DELHI DEVELOPMENT AUTHORITY
(DEV. CONTROL & PLG. WING)

No.F.1(22)94-MP

Minutes of the Technical Committee
held on 26.4.94 in the Conference Room of Vikas
Sadan, INA, Delhi Development Authority, New Delhi:-

Alternative plan with 22/18mtr. R/W between the periphery of the Central School & Co-educational school with two way traffic. vide drawing No CA-006/PPW-T-94

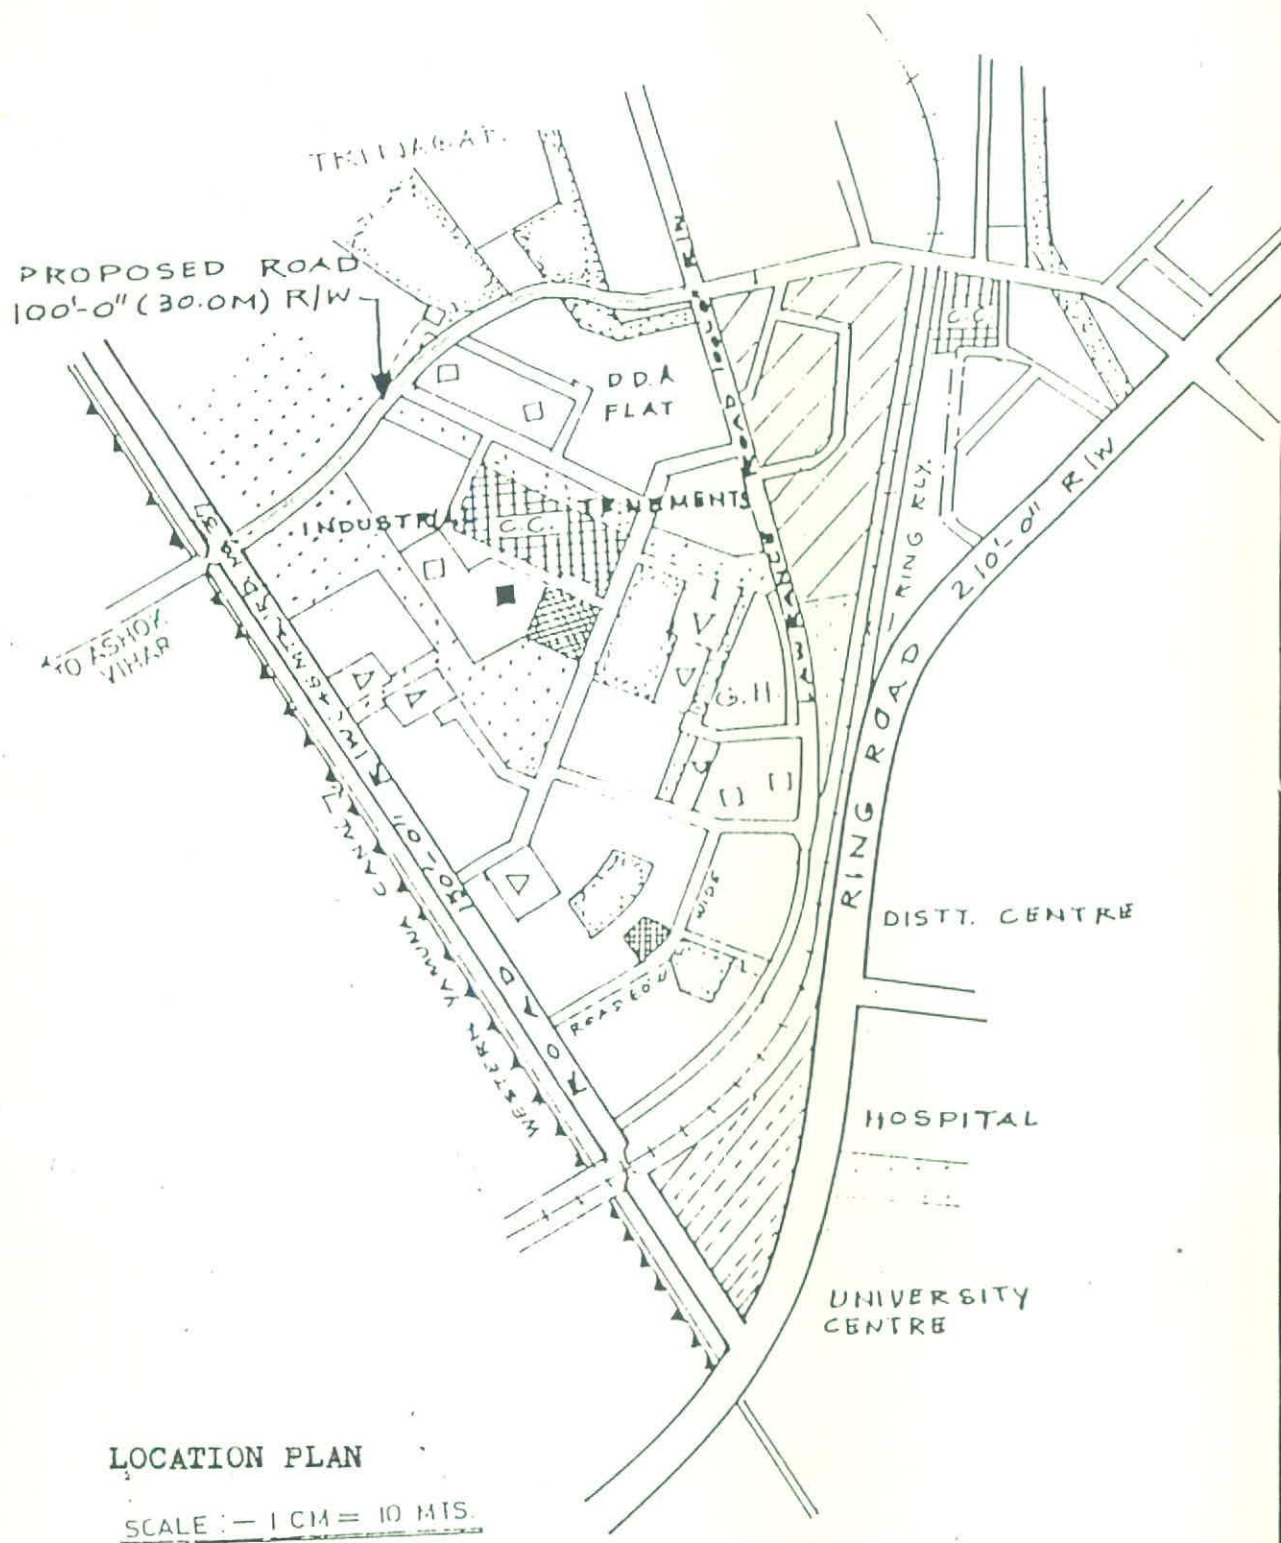
Commr. (Plg.) vide his Orders dated 30.12.93 desired that an alternative alignment without cutting across the Central School Playfield be worked out. The alternative alignment has been marked on a fresh P.T. Survey done by Survey Unit of PFW as indicated on the plan laid on the table. In this alignment the road is proposed between the periphery of Central School and the adjoining Co-Educational School, Narang Colony. In this 15 Mtr. is to be taken from both sides taking the boundary wall of Central School as central verge. This has been done to see that the buildings of Co-educational School are not affected. After this the road crosses the existing layout road of Trinagar/Narang Colony. In which a tubewall & Public lavatories are affected. It is then taken through the Developed Park where about 90 trees may be affected, it then join with the alignment as proposed earlier. Other structures affected are the same in the earlier alignment. Status of land falling under the road shall be clarified by the lands department once the alignment is agreed in principle.

10. The other alternative could be to reduce the R/W of this road. Number of trees required to be cut in different R/W's as per the survey drawing are as follows:

12. This is regarding the allotment of land falling under the proposed road as shown on draft alignment plan with 30 mtr. R/W. on license fee basis to the 'Trinagar Fracharini Sabha'. As per the alternative alignments proposals, land adjoining to the school shall not be required if the R/W is reduced to 23 mtr./18 mtr.

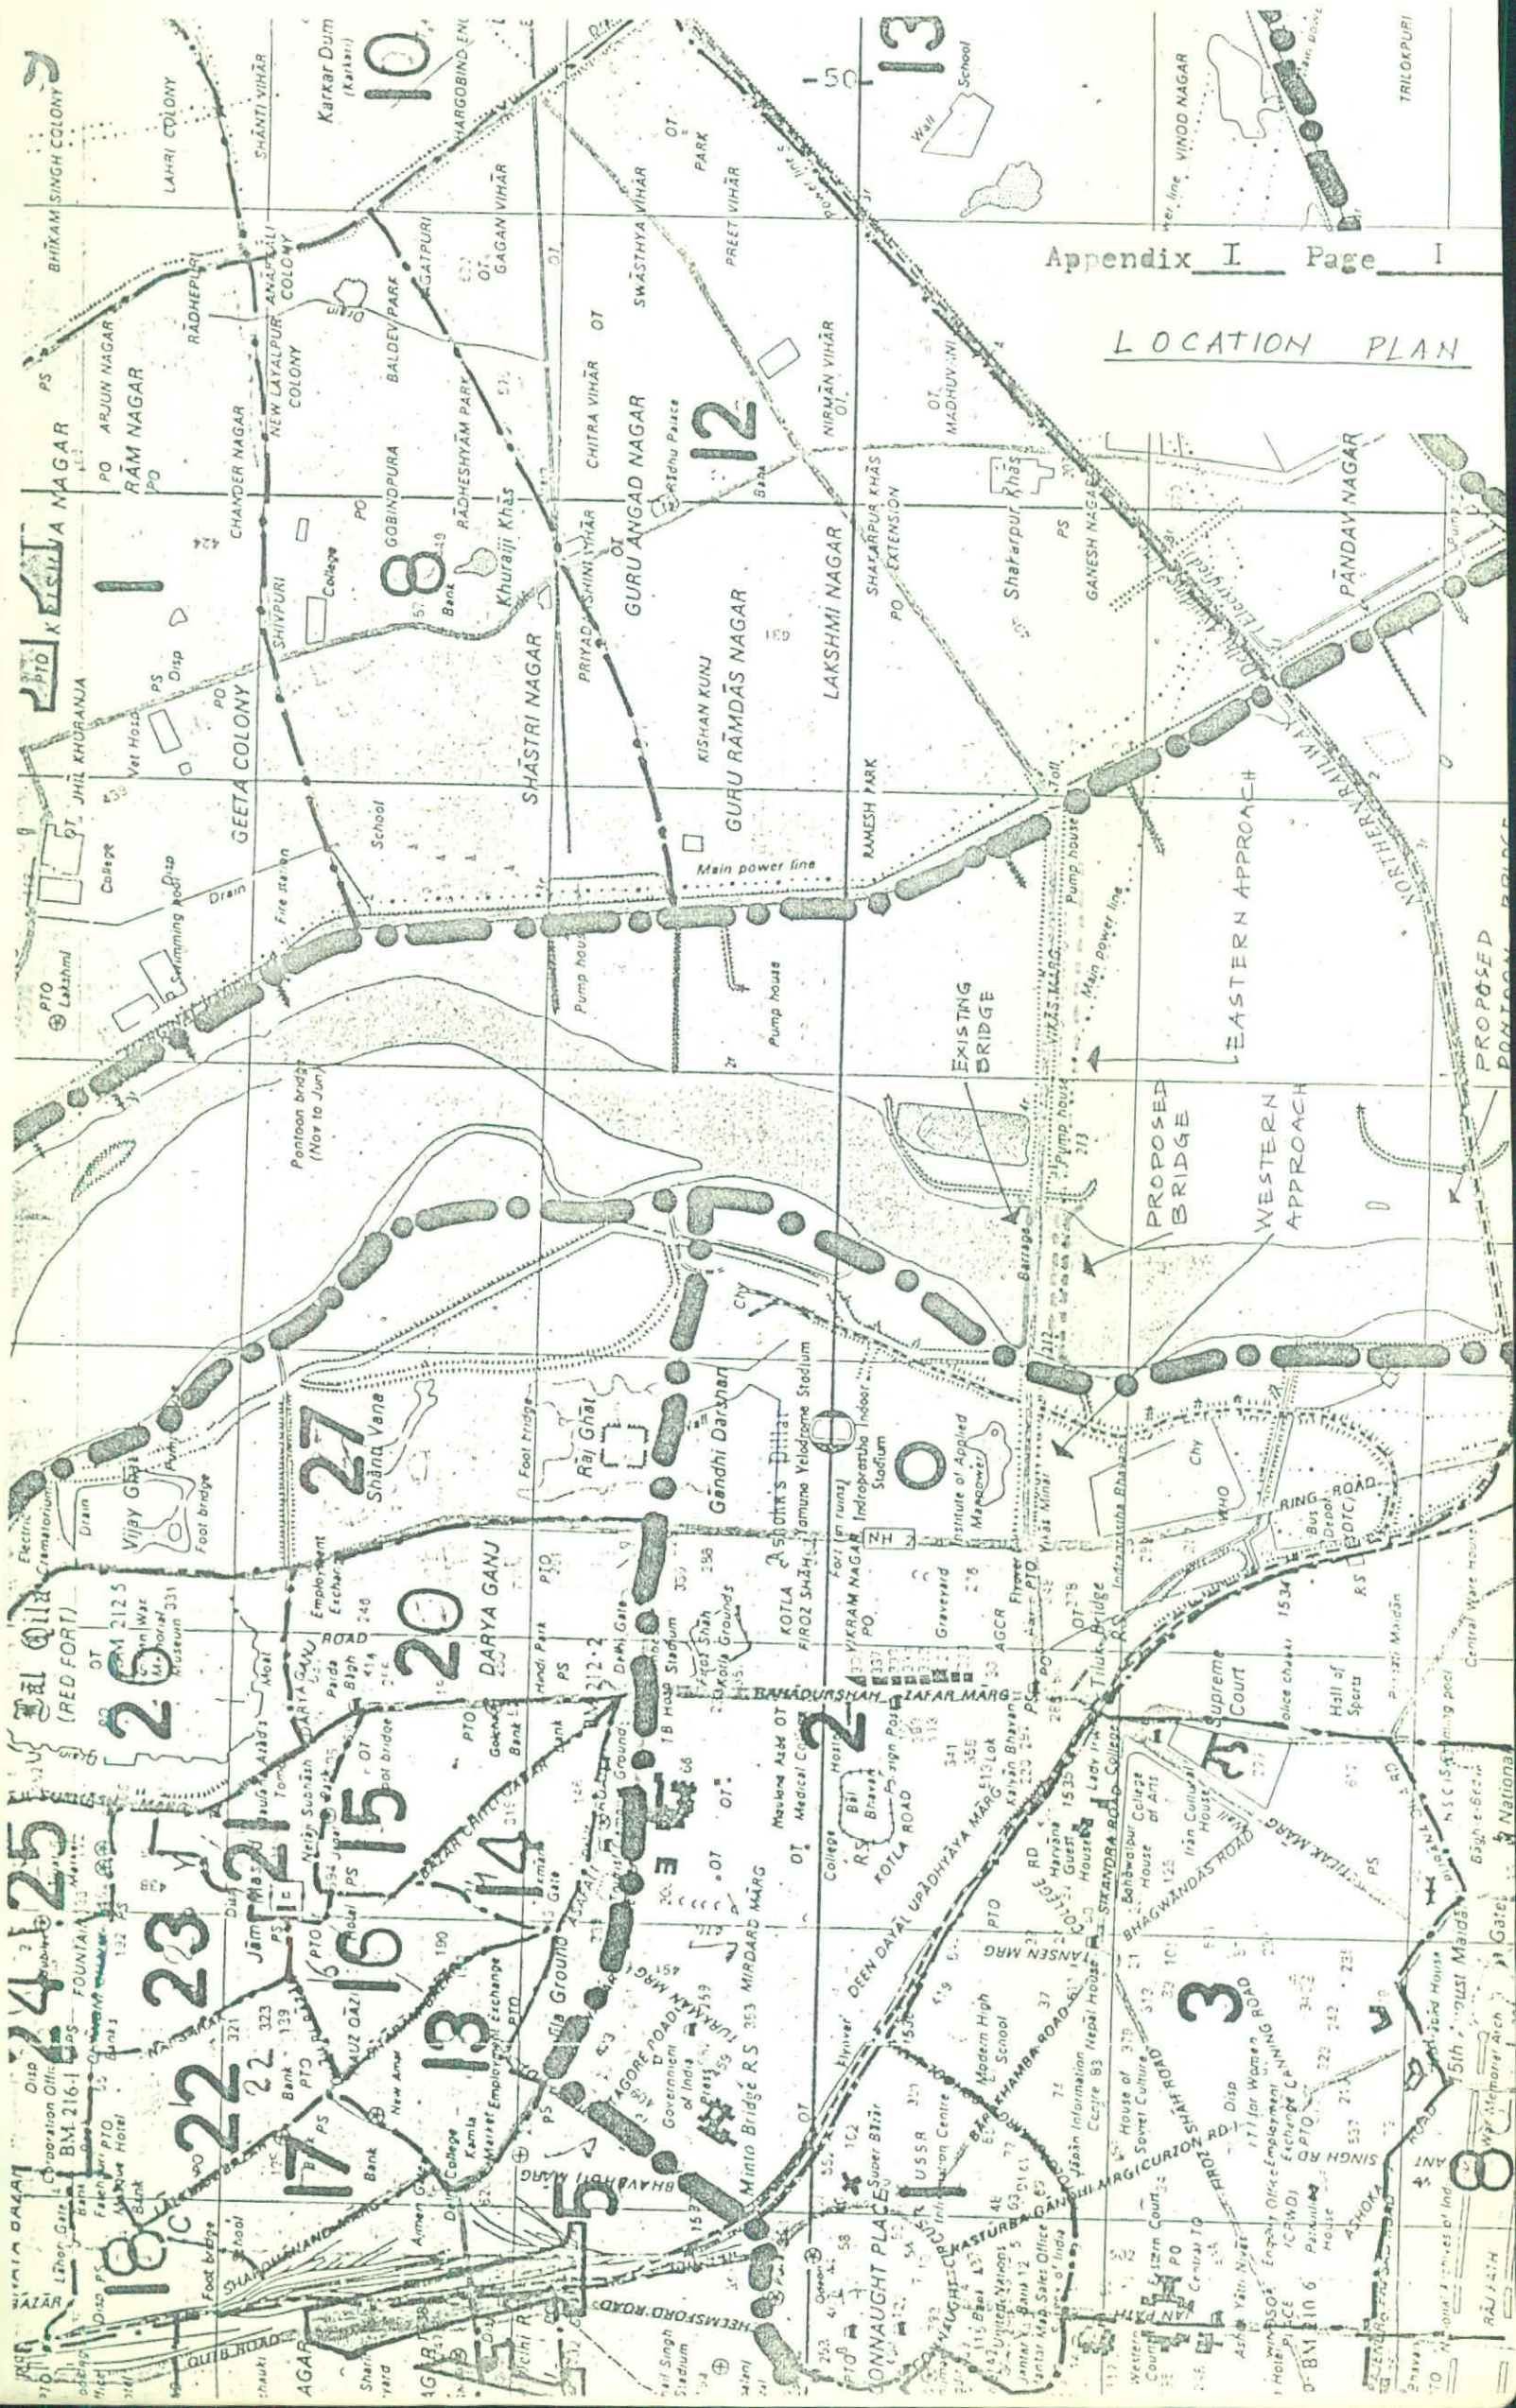
- 7.1 The alignment plan of the Eastern End approach Road to the new 4-lane bridge submitted now (in 1:500 scale) has been modified from the conceptual alignment plan submitted in the T.C held on 21.1.92.

In the previous case the eastern approach was approaching contiguous to the existing approach road. This was lying on an area in between the existing road and the existing pipe line. The modified plan shows the alignment approaching further South of the pipe line saving the land space between the pipe line and the existing road.

- 7.3 The intersection design of Eastern Bund Road - Vikas Marg at Laxmi Nagar should be an integral part of the comprehensive corridor development scheme which is being coordinated by the Commissioner (Transport), Govt. of Delhi.
- 7.4 In this regard the approved alignment plan of Bund Road from Laxmi Nagar to NOIDA More (i.e. upto NH-24 intersection) need to be consulted. Consideration of approach road to the proposed pantoon bridge near the vicinity of the Laxmi Nagar intersection is also required for efficient circulation of traffic.
- 7.5 Provision of cycle track cum scooter track is becoming necessary with the trend of traffic, which may be seen in consultation with the proposed Corridor Development Plan of Vikas Marg.
- 7.6 Consultation/confirmation of DESU, DWS & SDU and Telephone Deptts. with regard to shifting/modification of respective lines/poles etc. are required.

- 7.7 Secretary-Cum-Commr. (Transport) may be requested to expedite the finalisation of corridor improvement plan for the consideration of T.C/Authority/DUAC.
- 7.8 C.E(YBP) may be requested to submit the Lok Nayak Setu plans as approved by DUAC for the consideration of the Authority.
- 7.9 YBP, PWD shall plant 3 times the number of trees required to be cut. The trees shall be removed after obtaining the approval of Competent Authority.
- 7.10 Rehabilitation of eligible affected properties/structures shall be taken-up by PWD in consultation with land owning agency/agencies.
- 7.11 YBP, PWD requested for about 28 hact.(70 acrs) of land for removal of earth to construct embankment. Location is not specified. The ditches, a resultant of earth removal, creates environmental degradation, which needs simultaneous treatment.

Keeping in-view the environmental impact during as well as post construction period, the scope of the following suggestions should be explored :

- (i) Usage of fly ash mixed with residue of various construction sites and earth to reduce quantum of earth requirement.
- (ii) Removal of earth as per the river channelisation scheme, if any, in consultation with the concerned department/agency.
- (iii) Digging should be such shallow or filled thereafter so as not to create pond - like situation in future.

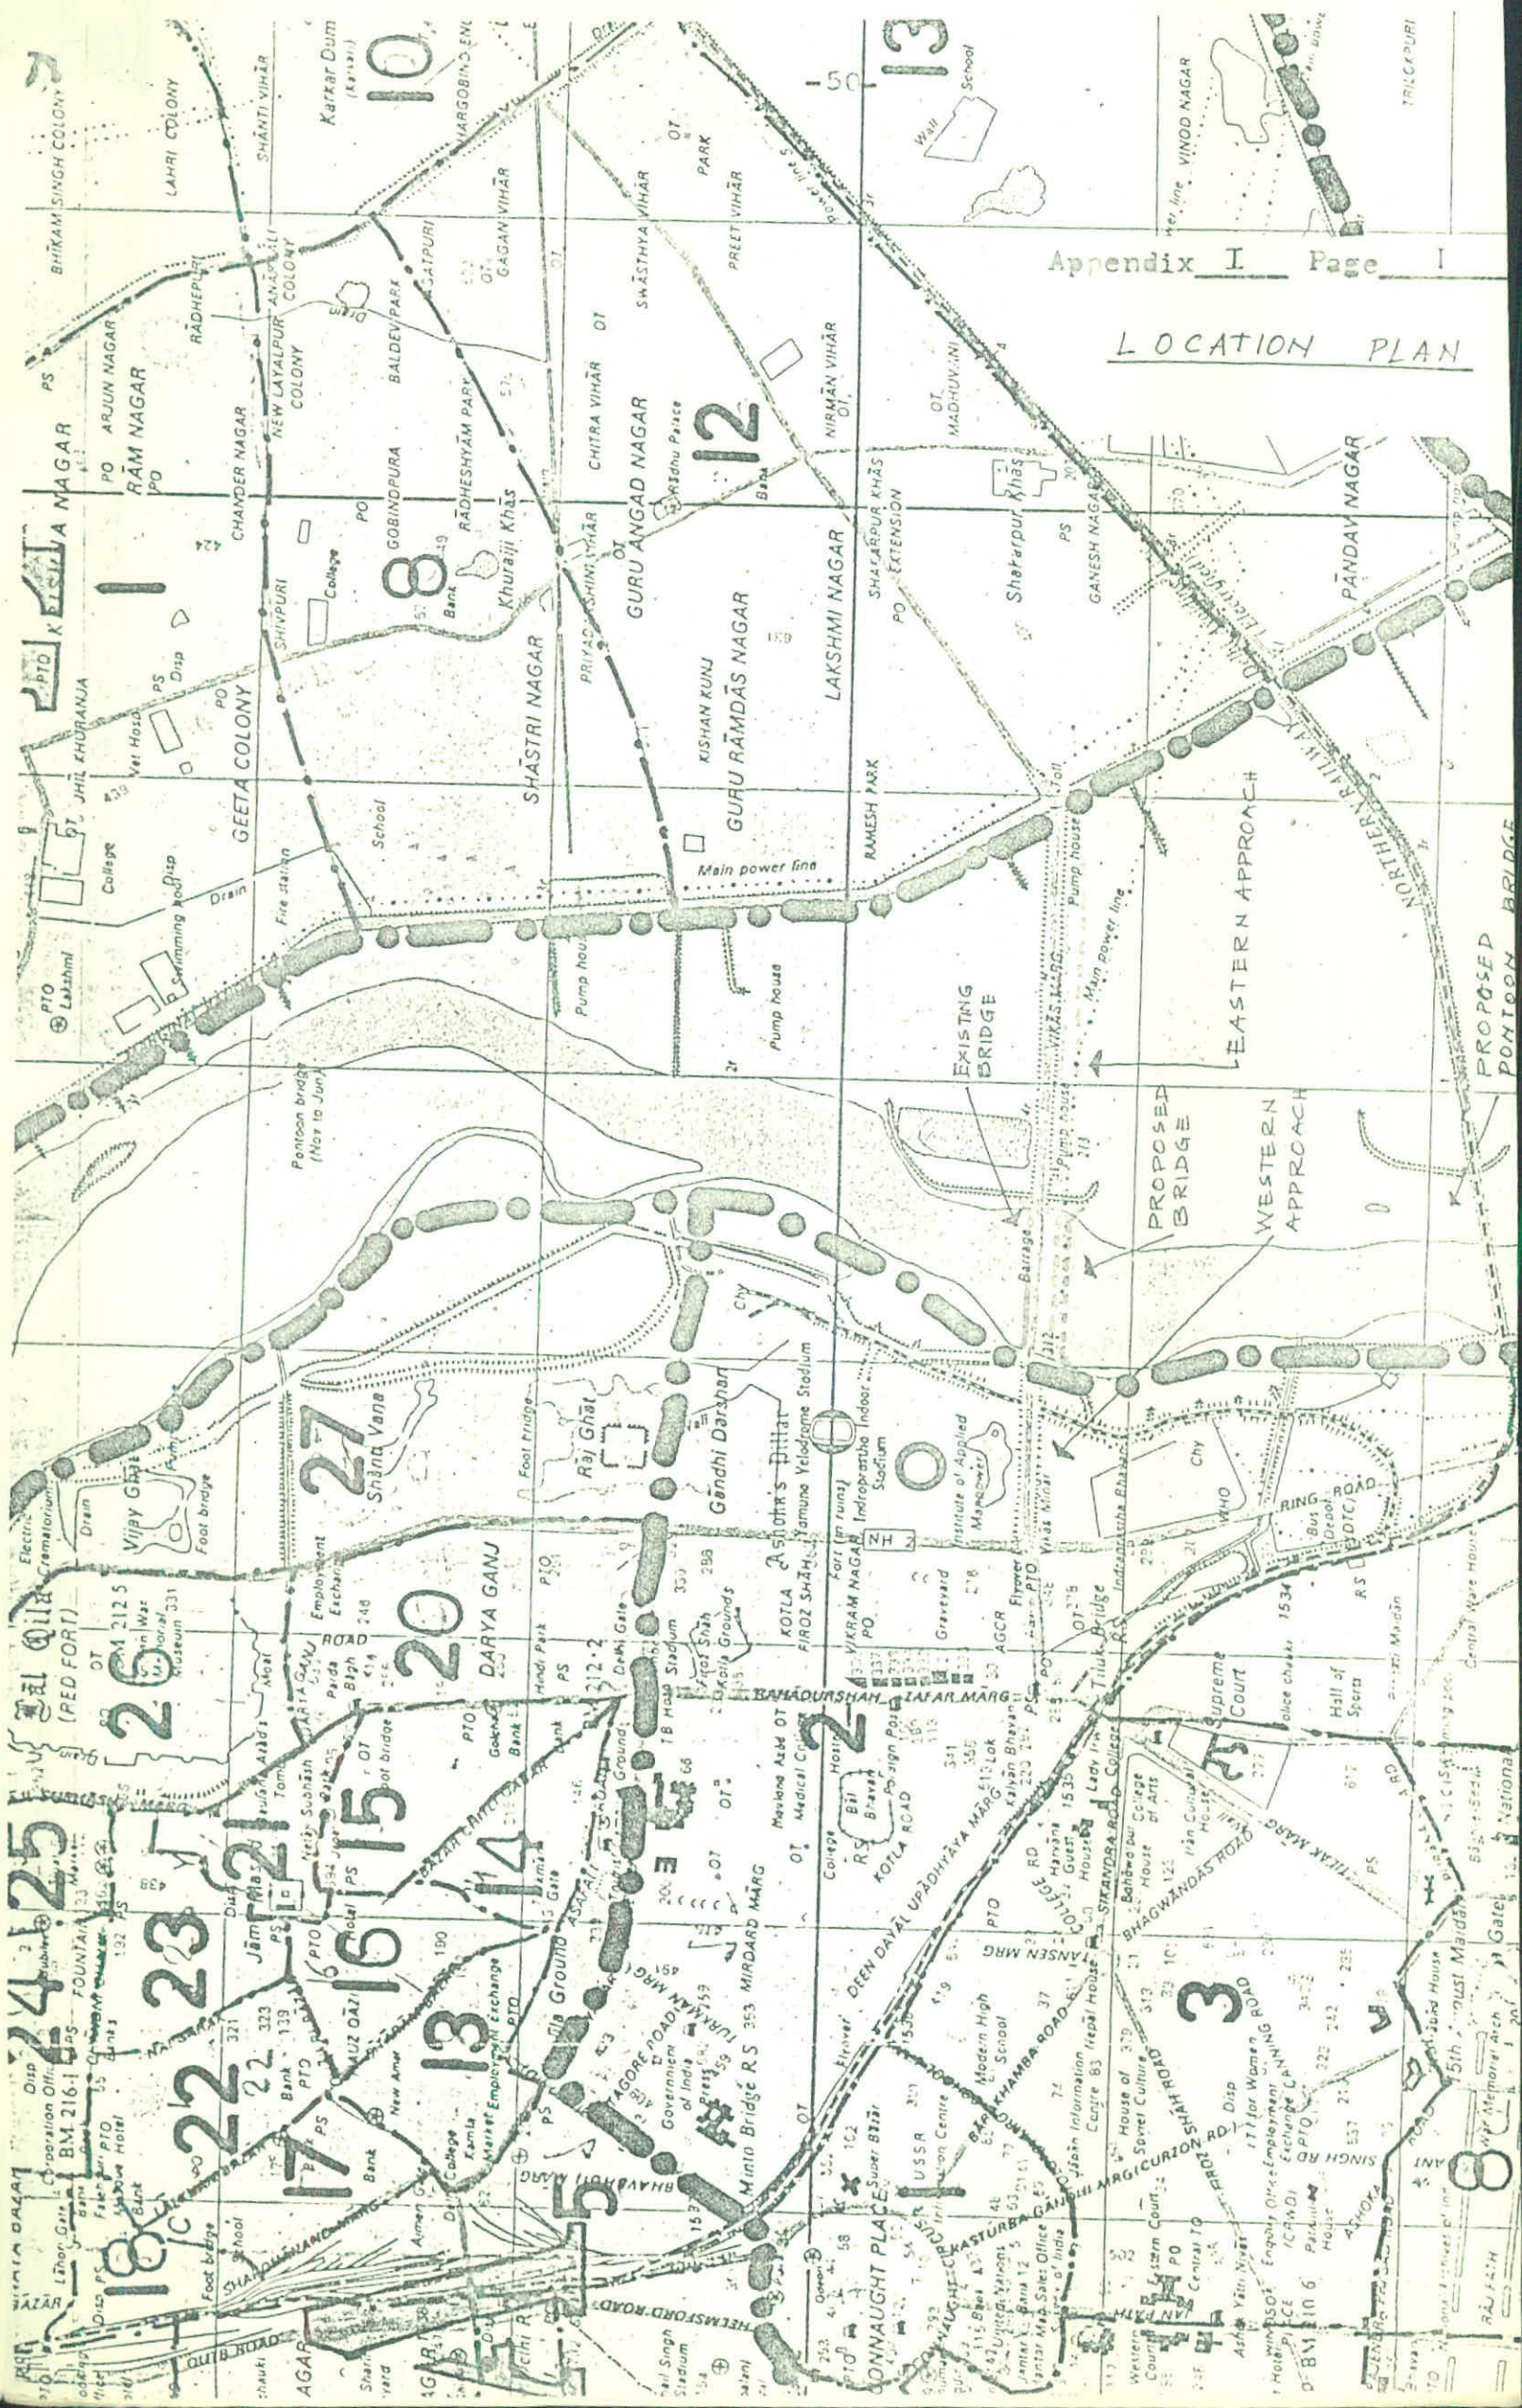
- 7.3 The intersection design of Eastern Bund Road - Vikas Marg at Laxmi Nagar should be an integral part of the comprehensive corridor development scheme which is being coordinated by of Commissioner (Transport), Govt. of Delhi.
- 7.4 In this regard the approved alignment plan of Bund Road from Laxmi Nagar to NOIDA More (i.e. upto NH-24 intersection) need to be consulted. Consideration of approach road to the proposed pantoon bridge near the vicinity of the Laxmi Nagar intersection is also required for efficient circulation of traffic.
- 7.5 Provision of cycle track cum scooter track is becoming necessary with the trend of traffic, which may be seen in consultation with the proposed Corridor Development Plan of Vikas Marg.
- 7.6 Consultation/confirmation of DESU, DWS&SDU and Telephone Deptts. with regard to shifting/modification of respective lines/poles etc. are required.

- 7.7 Secretary-Cum-Commr. (Transport) may be requested to expedite the finalisation of cooridor improvement plan for the consideration of T.C/Authority/DUAC.
- 7.8 C.E(YBP) may be requested to submit the Lok Nayak Setu plans as approved by DUAC for the consideration of the Authority.
- 7.9 YBP, PWD shall plant 3 times the number of trees required to be cut. The trees shall be removed after obtaining the approval of Competent Authority.
- 7.10 Rehabilitation of eligible affected properties/structures shall be taken-up by PWD in consultation with land owning agency/agencies.
- 7.11 YBP, PWD requested for about 28 hact.(70 acrs) of land for removal of earth to construct embankment. Location is not specified. The ditches, a resultant of earth removal, creates environmental degradation, which needs simultaneous treatment.

Keeping in-view the environmental impact during as well as post construction period, the scope of the following suggestions should be explored :

- (i) Usage of fly ash mixed with residue of various construction sites and earth to reduce quantum of earth requirement.
- (ii) Removal of earth as per the river channelisation scheme, if any, in consultation with the concerned department/agency.
- (iii) Digging should be such shallow or filled thereafter so as not to create pond - like situation in future.
